SERVICE LETTER NUMBER 162			
TITLE: Main gear actuator replacement			
BY: R. GLASS	AIRCRAFT MAKE/MODEL(S):	FLOAT MODEL(S):	NOTE(S):
APP: J. SORTOR	QUEST MODEL 100 KODIAK CESSNA MODEL 208/208B CARAVAN	7000 and 8750	Optional compliance S/L P/N 1008557 ECO 24131
DATE: 8/24/2015			
REV: A

Gear actuator assembly is having water intrusion into the main housing where the greased mechanisms are located.

Install float main gear actuator PN 1003510 (1 each) in accordance with the instructions in the technical data section of this service letter.

Figure 1

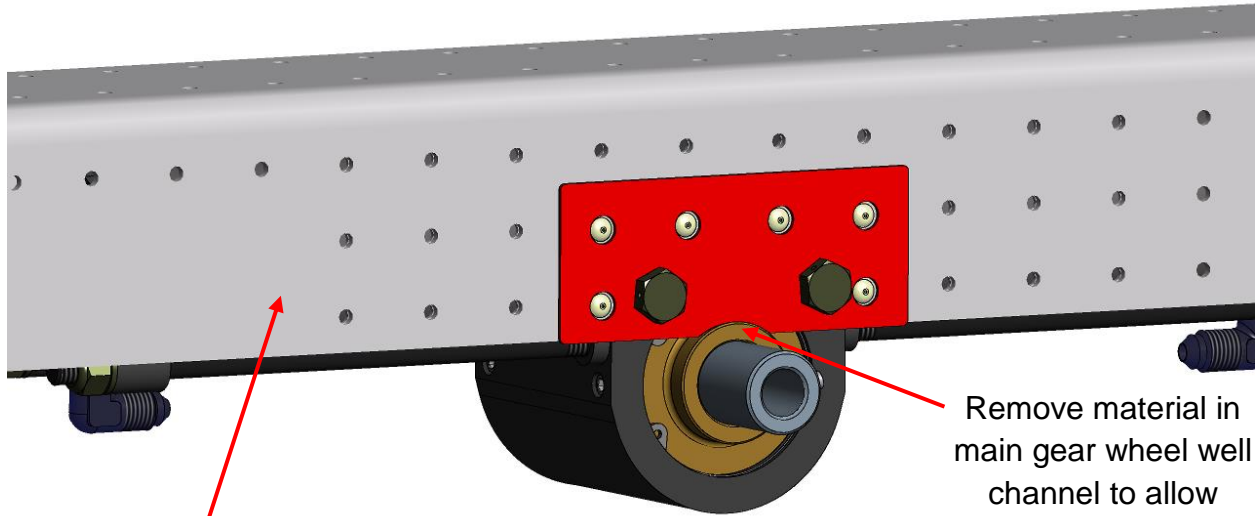
Note: Use template part number 1008665 found in this kit to locate the clearance area needed for the new actuator to be installed. See figure 1 for reference.

Remove material in main gear wheel well channel to allow clearance for the replacement actuator
